RENESAS TECHNICAL UPDATE

Product Category	MPU & MCU	Document No.	TN-16C-A211A/E	Rev.	1.00
Title	Errata to R32C/116A Group User's Manual: Hardware		Information Category	Technical Notification	
Applicable Product	R32C/116A Group	Lot No.	Reference Document	R32C/116A Group User's Manual: Hardware Rev. 1.00 (REJ09B0575-0100)

This document describes corrections to the R32C/116A Group User's Manual: Hardware, Rev. 1.00. The corrections are indicated in red in the list below.

Figure 8.1 Clock Generation Circuitry

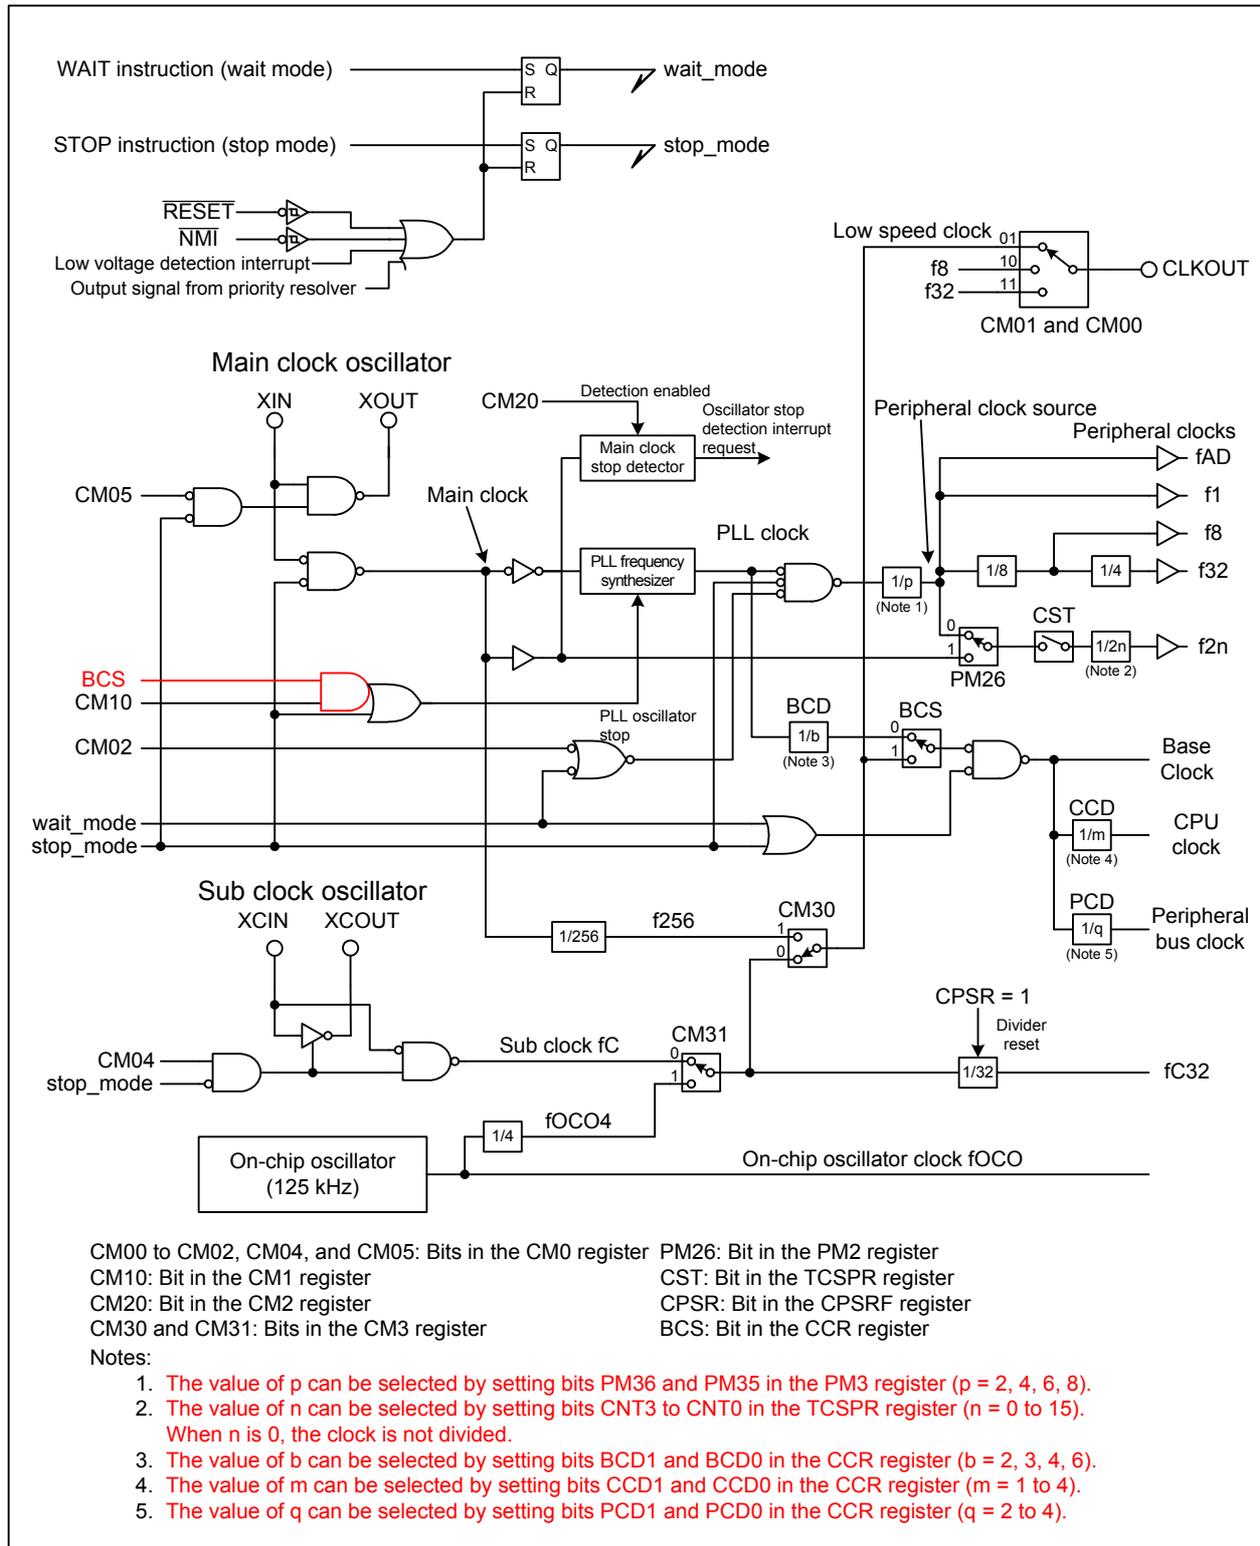
•Page 72 of 541, Figure 8.1 is corrected as follows:

Figure 21.1 CRC Calculator Block Diagram

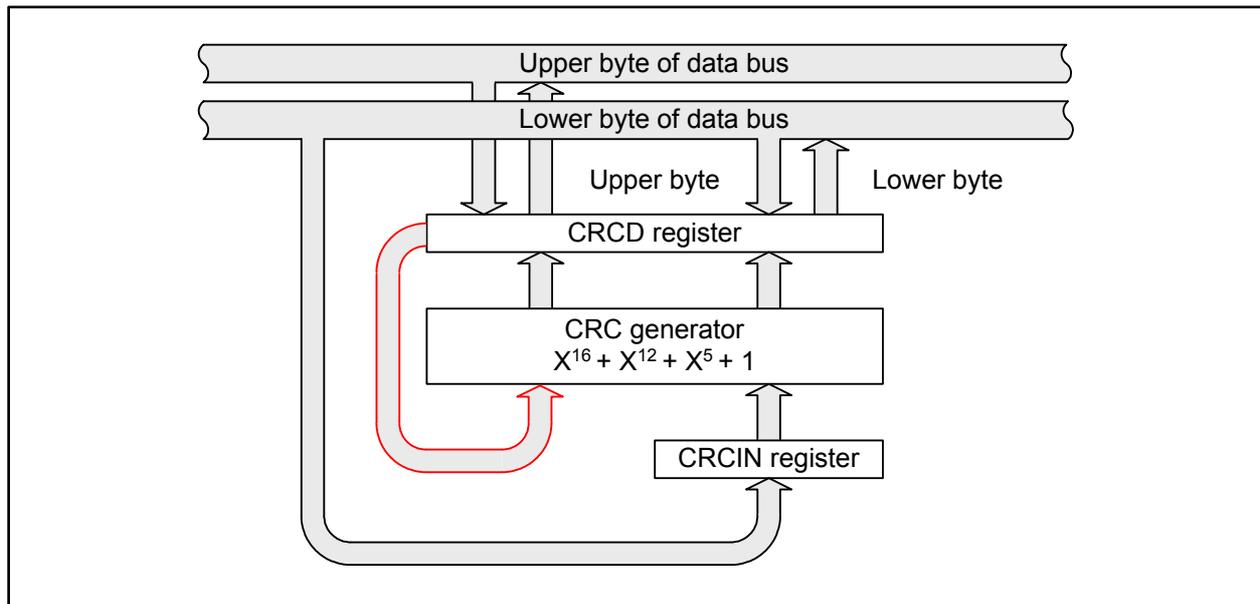
- Page 305 of 541, description in 19.1.5 is modified as follows:
 “In repeat sweep mode 1, the analog voltage applied to eight selected pins including **one to four** prioritized pins is repeatedly converted into a digital code. Table 19.6 lists specifications of repeat sweep mode 1.”
- Page 305 of 541, description for the function in Table 19.6 is modified as follows:
 “**The analog voltage applied to eight selected pins including one to four prioritized pins is repeatedly converted into a digital code. The prioritized pins are selected by setting bits SCAN1 and SCAN0 in the AD0CON1 register and bits APS1 and APS0 in the AD0CON2 register**”
- Page 314 of 541, description “AD0i register” in the ninth bullet point of 19.3.2 is modified as follows:
 “**AD00 register**”
- Page 317 of 541, Figure 21.1 is corrected as follows:

Figure 26.1 Typical I/O Pin Block Diagram (i = 0 to 19; j = 0 to 7)

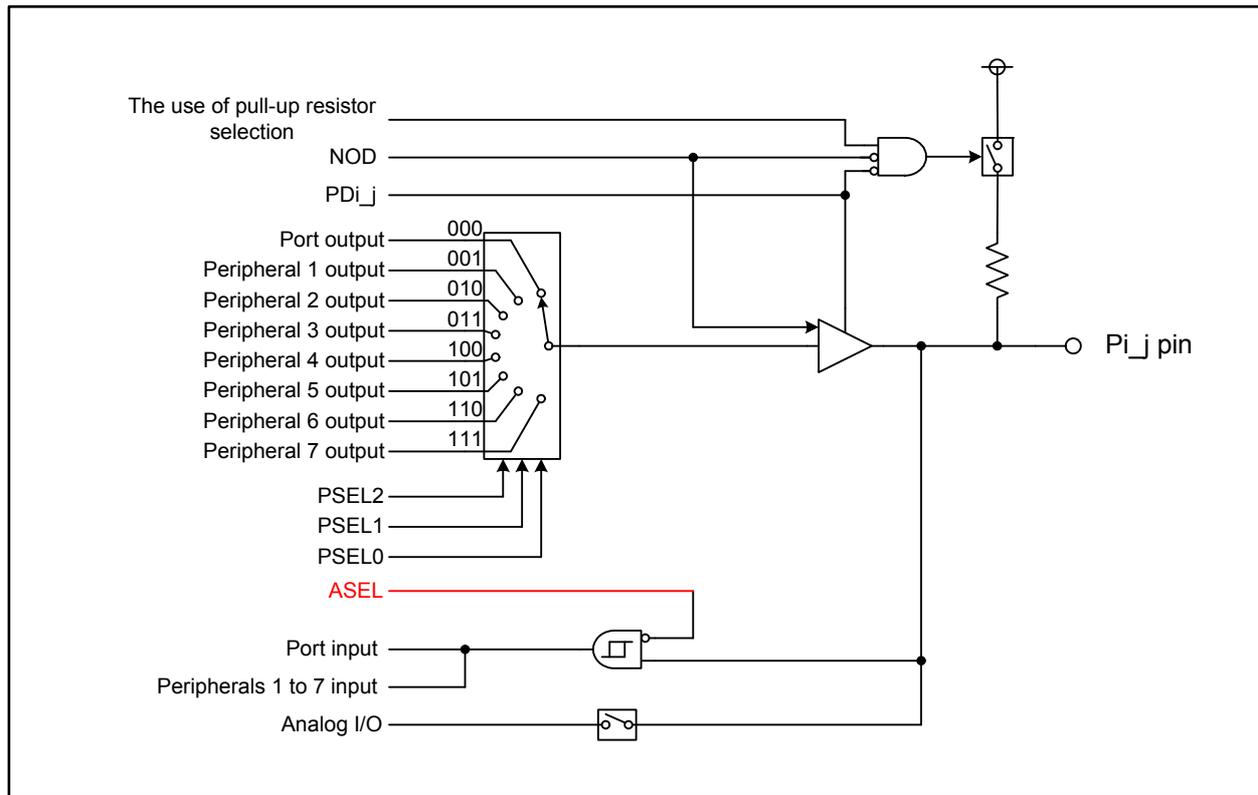
•Page 404 of 541, Figure 26.1 is corrected as follows (refer to TN-16C-A200A/E):
